WOLLONGONG CITY COUNCIL

Local Transport Forum Minutes

9 June 2026

Item 4.1 - HUNTLEY, Cleveland Road - Cleveland Road Upgrade

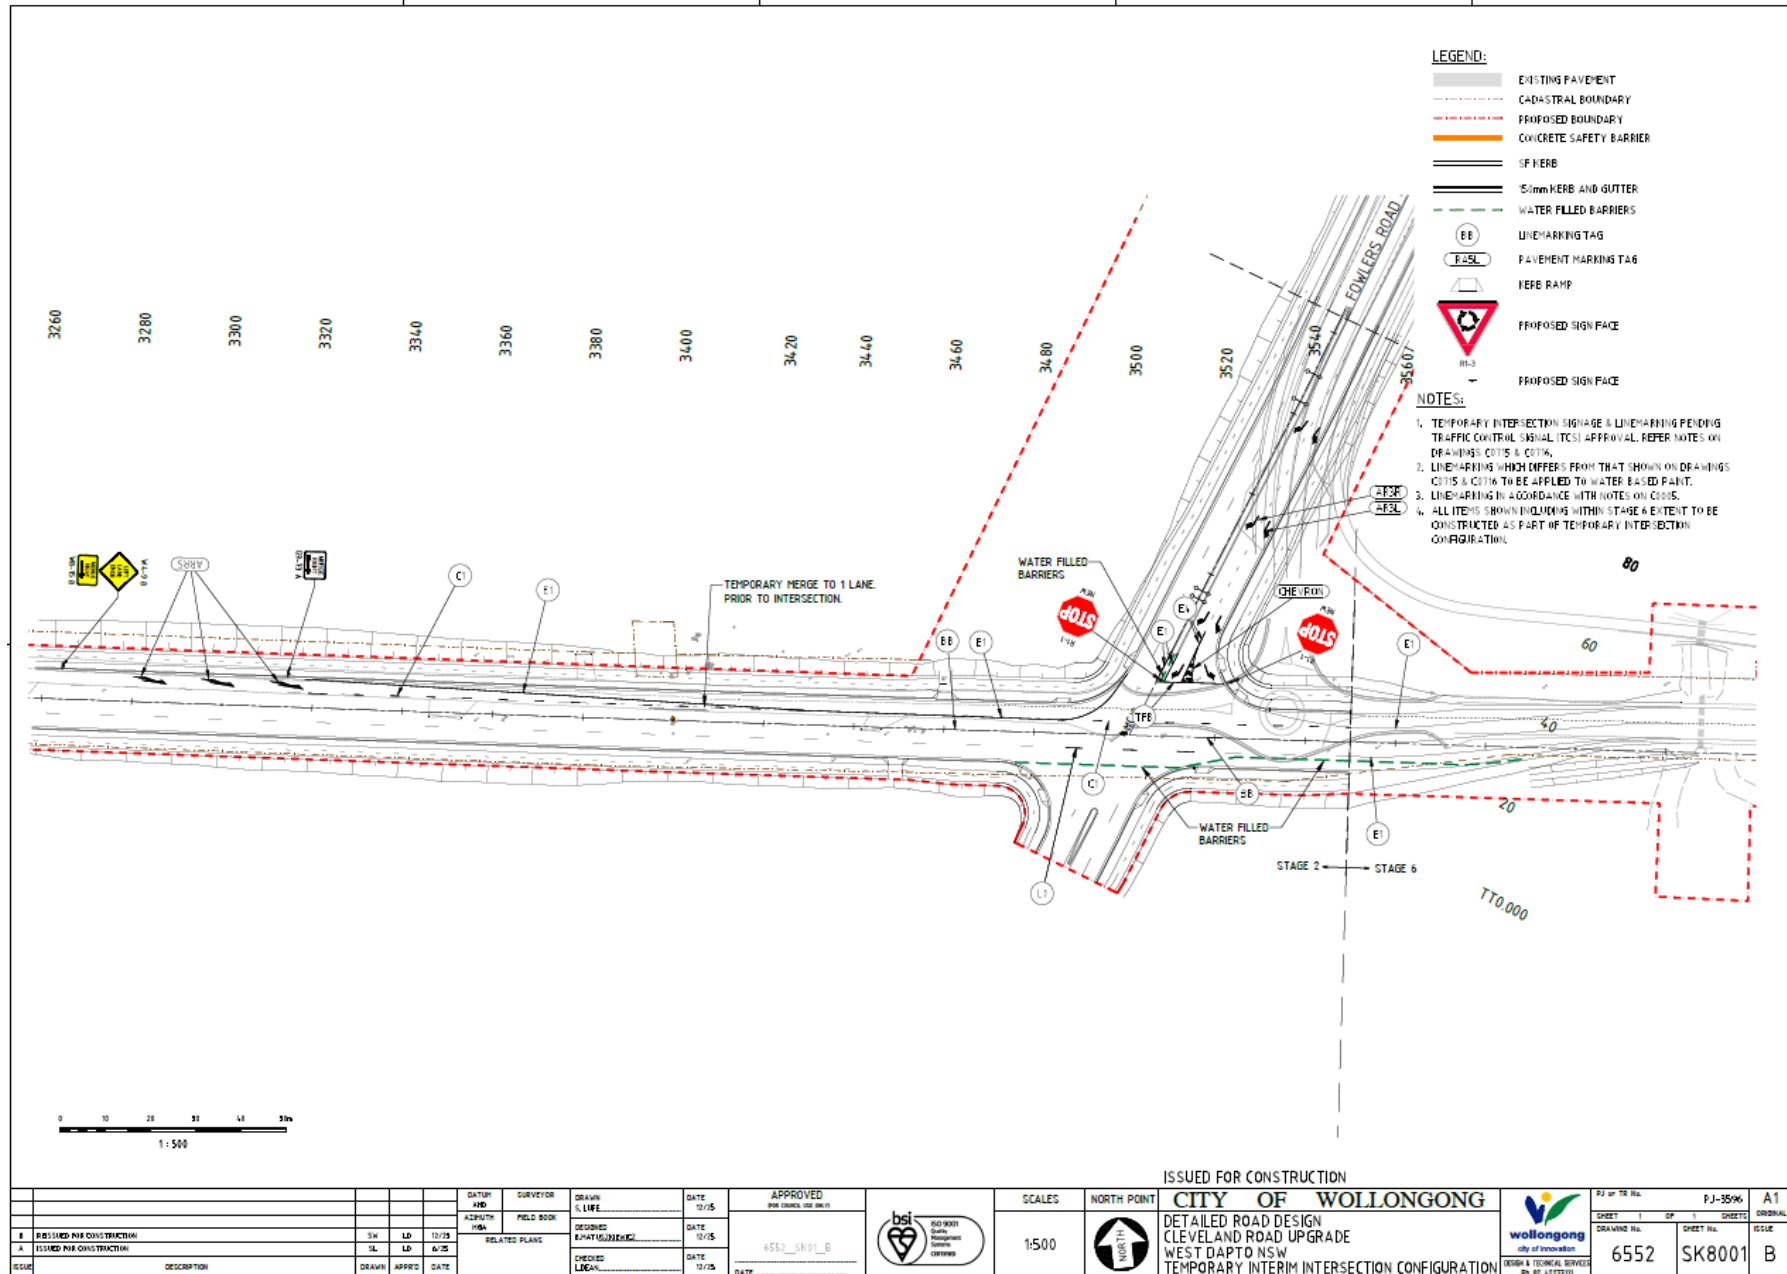
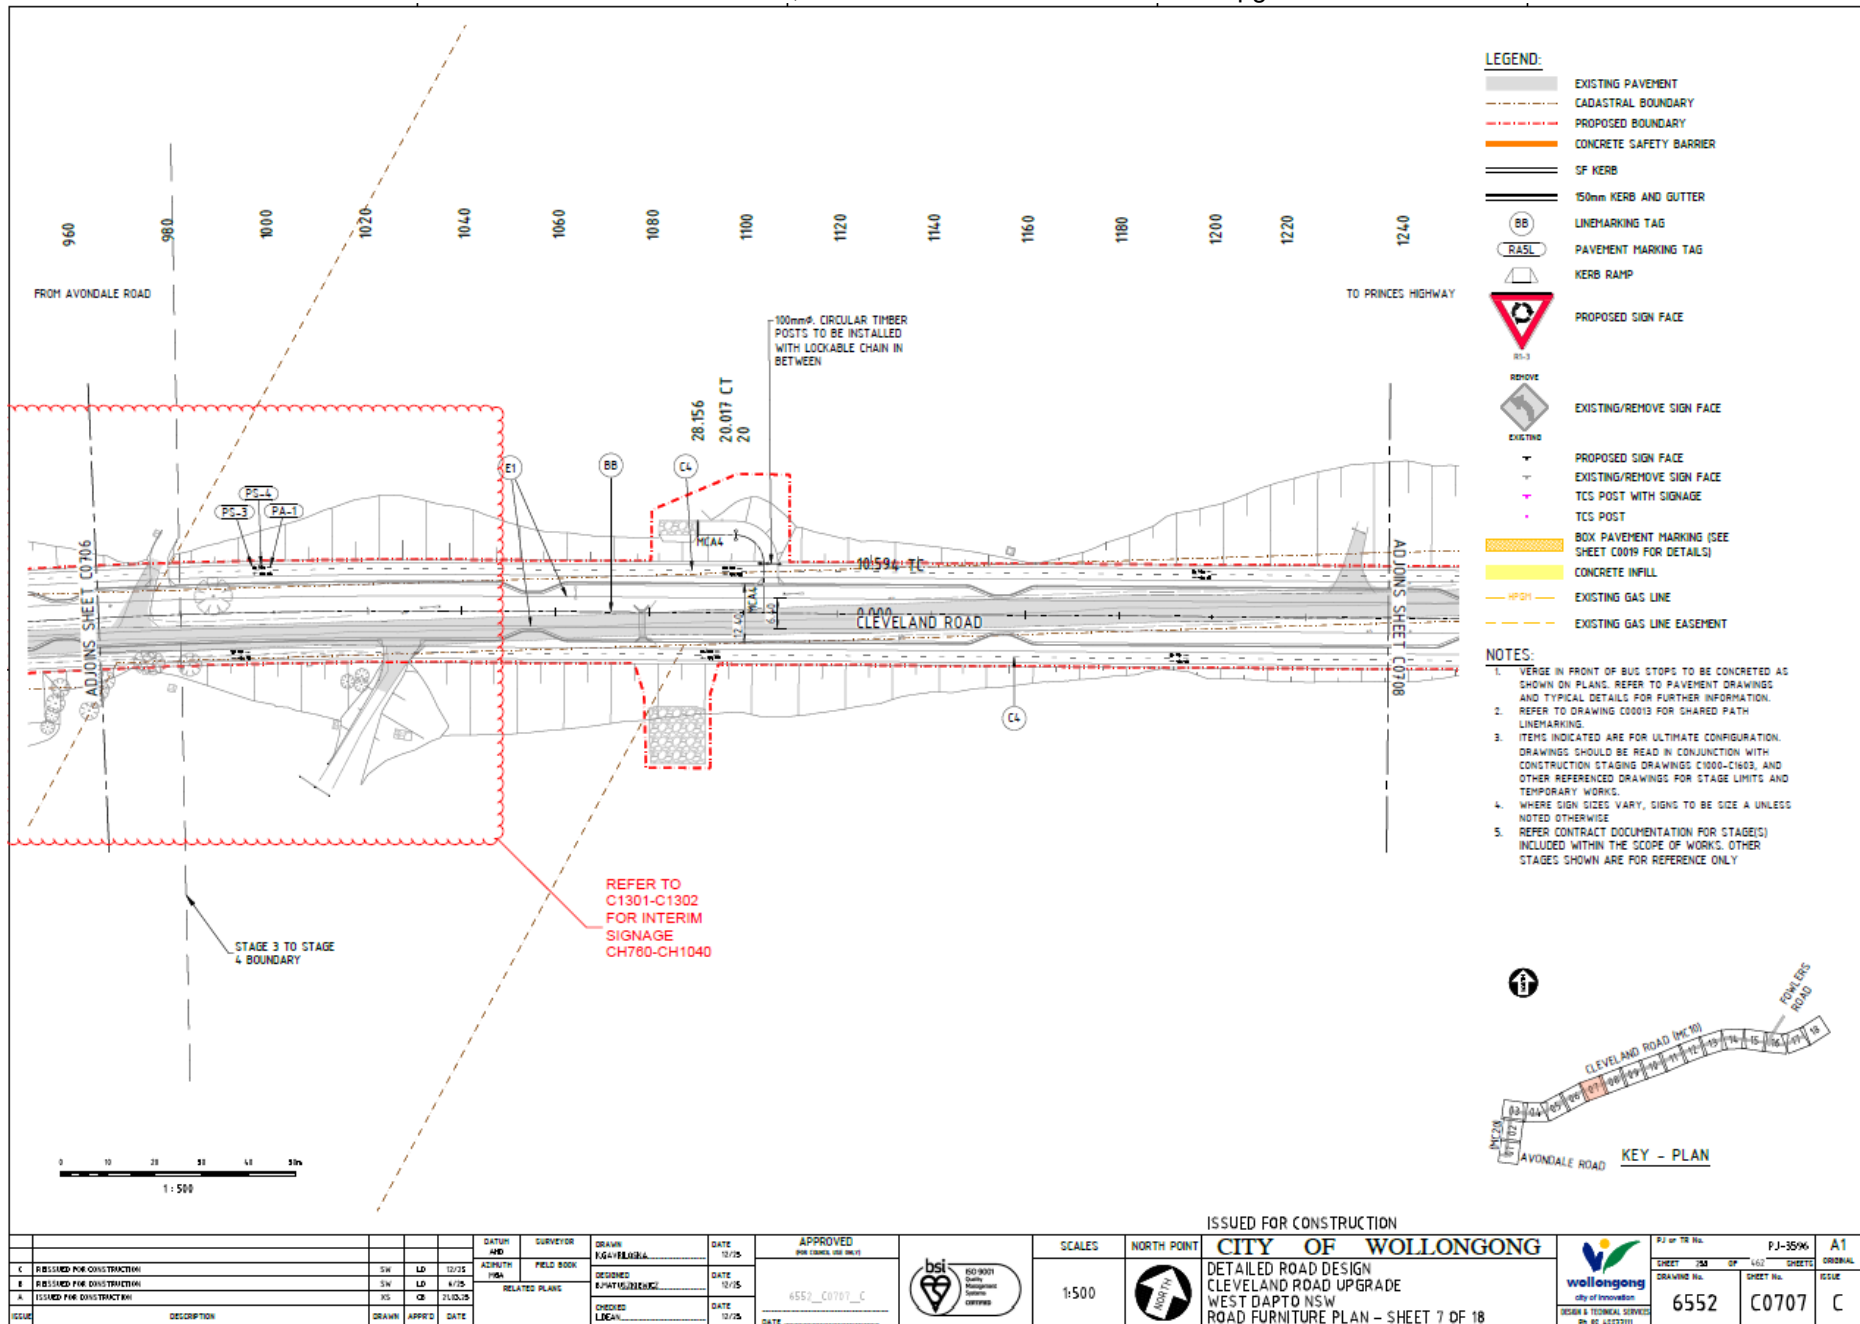
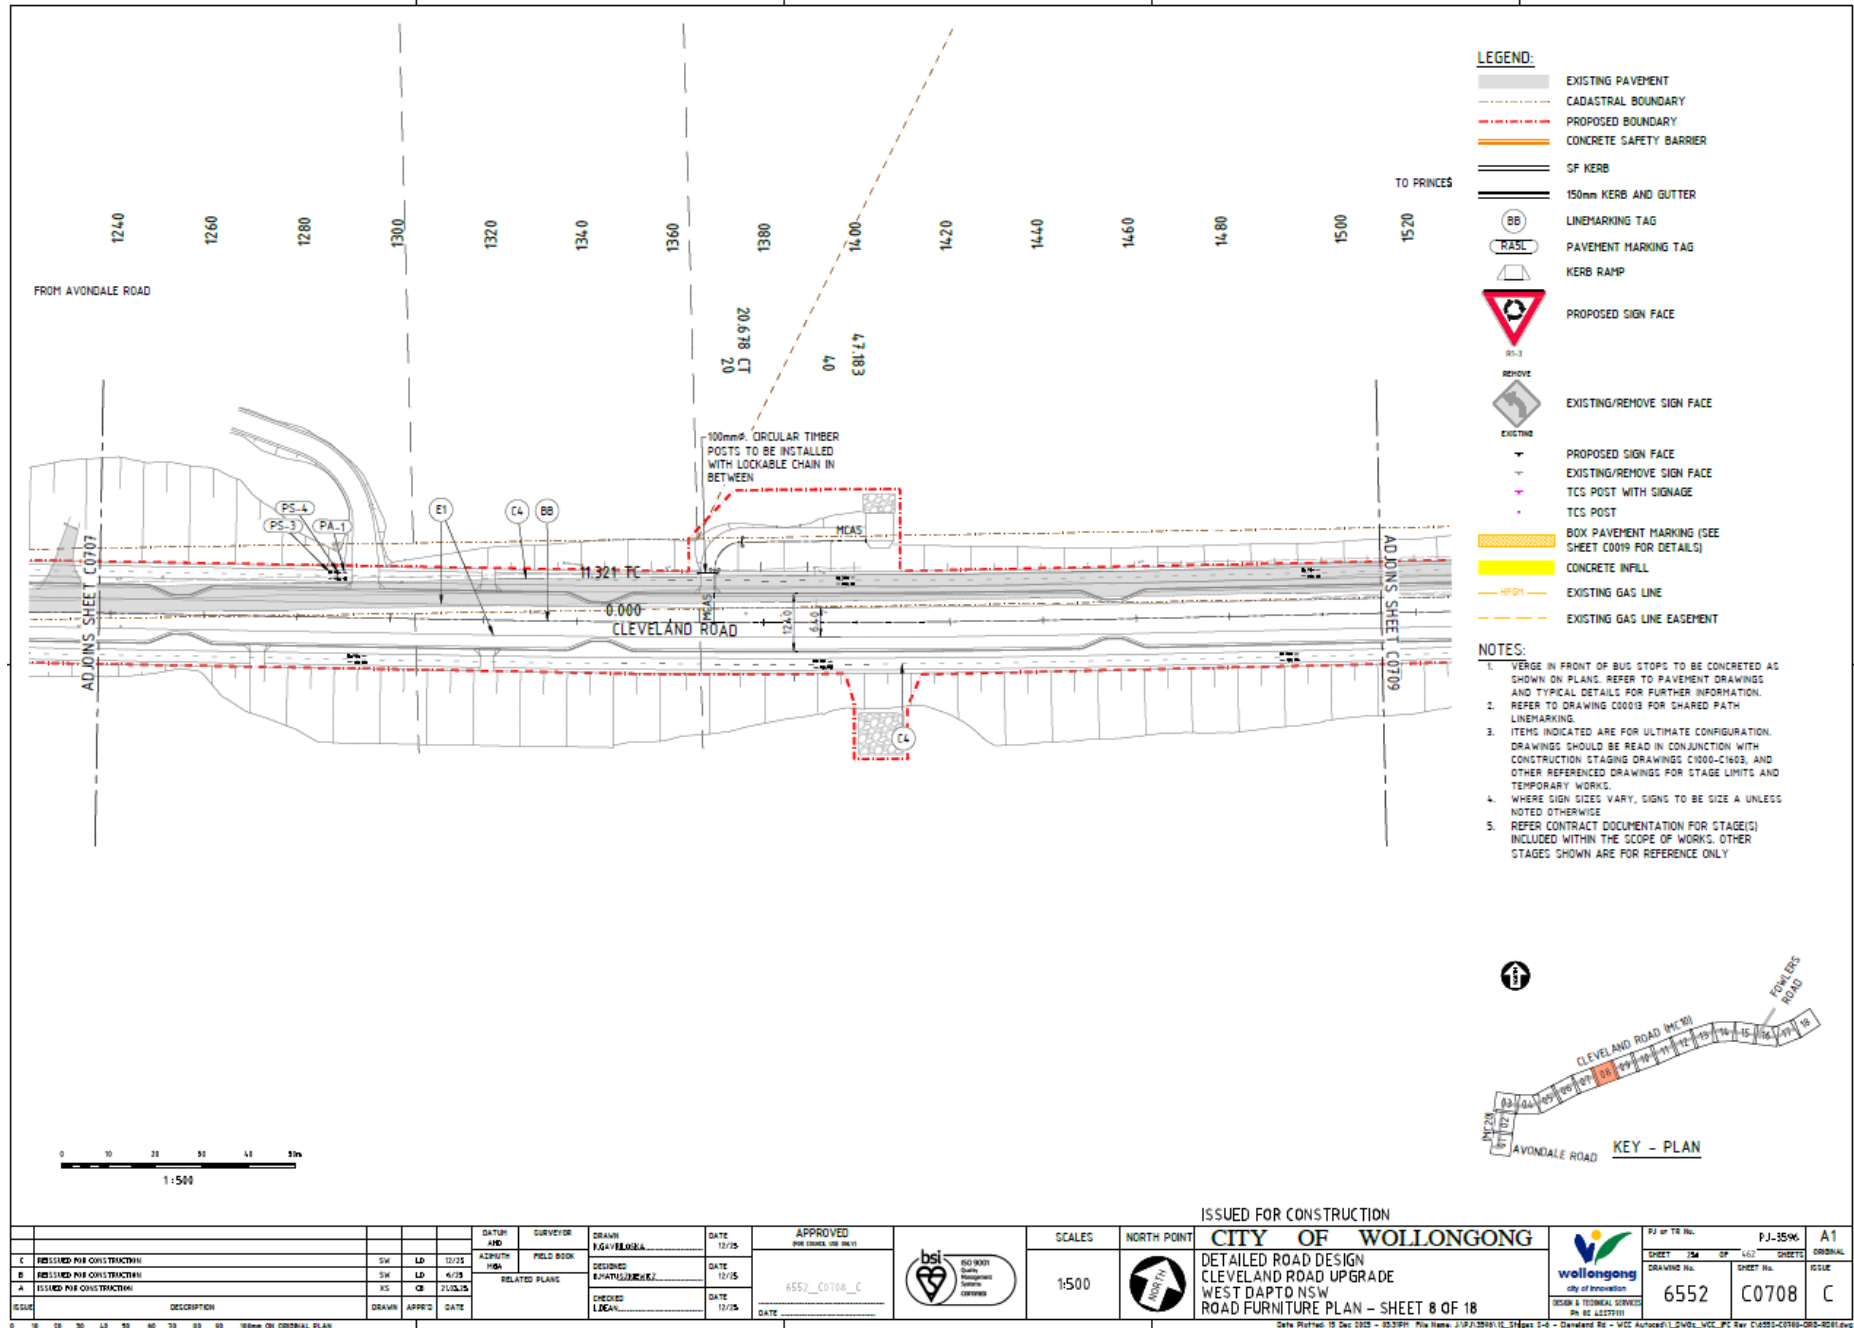
Forum Member /Guest	Advice	Council Comment
TfNSW	a) There is no proposed widening of the shared path at bus stop locations. There is likely to be conflict between people waiting for the bus and shared path users. This risk is expected to increase given the corridor functions as a movement route, with higher bicycle travel speeds likely. It is recommended that the shared path be widened at bus stops to improve separation between waiting passengers & path users, consistent with council standard drawings & TS 04951.4. b) P26/C0709 – bus zone prior to kerb extension westbound c) P28/C0711 –bus zone sign eastbound is missing and requires an R5-20(L) sign. d) P33/C0716 – No Stopping at the wombat crossing. T-intersection warning signage may be warranted e) P37/C0701 – speed zone sign located within a bus zone. Consider advanced warning signage for the Avondale Road roundabout. Transition from 80 km/h to 50 km/h suggests advance warning would likely be beneficial (AS1742.2, Section 2.6.4) f) P39/C0703 – possible drafting error over bridge (grey rectangle)	a) Proposed bus zones are temporary. Ultimate locations are identified through relevant DA processes. Condition #1 added to ensure temporary and final bus stops will be DSAPT compliant. b) These are calming points (not crossing points). c) Condition #2 added d) Condition #3 added. e) Condition #4 added. f) Plans to be adjusted to remove error.

The interim and ultimate staged Plans 6552-SK8001-DRG-RD01, 6552-10-C1205, 6552-10-C1301-C1302, 6552-C0707-C0716 (interim) and 6552-C0701-C0761 (ultimate) be approved subject to:

1. All proposed bus zones to be designed in accordance with Councils minimum standard drawings including, but not restricted to, managing conflicts between shared path users and public transport users.

2. Eastbound Bus Zone on plan P28/C0711 having a close sign to end the zone. An R5-20(L) sign is required.
3. Plan to be reviewed to determine whether additional no stopping signs/lines and intersection warning signs are required adjacent to wombat crossings and on approach to intersections in accordance with relevant Standards
4. Relocate proposed speed zone sign to before the bus zone sign (in the no stopping zone) and install roundabout warning signs on approaches to the roundabout on Avondale Road in accordance with AS1742.2, Section 2.6.4.
